Access Compliance Report Public Rights-of-Way (Curb Ramps)

Intersection ID: 10917 Main Street: E 25TH ST **Cross Street: N DAVIDSON ST** Location: ADA ID: 5268DEB94348 Ramp Type: BlendTrans1 Initial Pass/Fail: Fail **Overall Compliance: No Severity Score:** 25

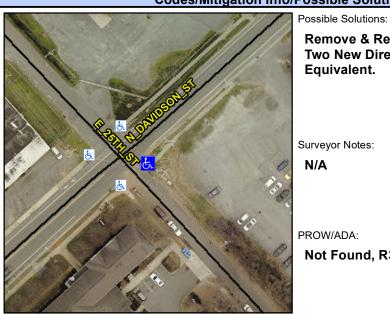
N/A	Ramp Length (in)	69.0	Yes	BlendTrans Slope (%)	4.0
Yes	Ramp Width (in)	60.0	No	BlendTrans XSlope (%)	11.7
N/A	Flare Type LT	N/A	N/A	Flare Type RT	N/A
N/A	Flare Slope LT (%)	N/A	N/A	Flare Slope RT (%)	N/A
N/A	Flare Traversable LT?	N/A	N/A	Flare Traversable RT?	N/A
N/A	Landing Length (in)	N/A	N/A	DWS Provided?	N/A
N/A	Landing Width (in)	N/A	N/A	DWS Contrast?	N/A
N/A	Landing Slope (%)	N/A	N/A	DWS Length (in)	N/A
N/A	Landing X Slope (%)	N/A	N/A	DWS Full Width?	N/A
N/A	Landing Curb? (Y/N)	N/A	N/A	DWS Offset (in)	N/A
N/A	Shared Landing?	N/A			
N/A	Gutter Ponding?	N/A	N/A	Gutter Slope (%)	N/A
N/A	Gutter Lip Ht (in)	N/A	N/A	Gutter X Slope (%)	N/A
N/A	Painted X Walk1?	No	N/A	Painted X Walk2?	N/A
	X Walk 1 Direction	To SW		X Walk 2 Direction	N/A
	X Walk 1 Width (in)	N/A		X Walk 2 Width (in)	N/A
	X Walk 1 Slope (%)	2.6		X Walk 2 Slope (%)	N/A
	X Walk 1 X Slope (%)	4.7		X Walk 2 X Slope (%)	N/A
N/A	Ramp inside XWalk1?	N/A	N/A	Ramp inside XWalk2?	N/A

E 25TH ST Street 1 Name Stop Condition-Street 1 StopSign Street 2 Name N/A Stop Condition-Street 2 N/A **Remove & Replace Curb Ramp With Two New Directional Ramps or** Equivalent.

Not Found, R304.5.3
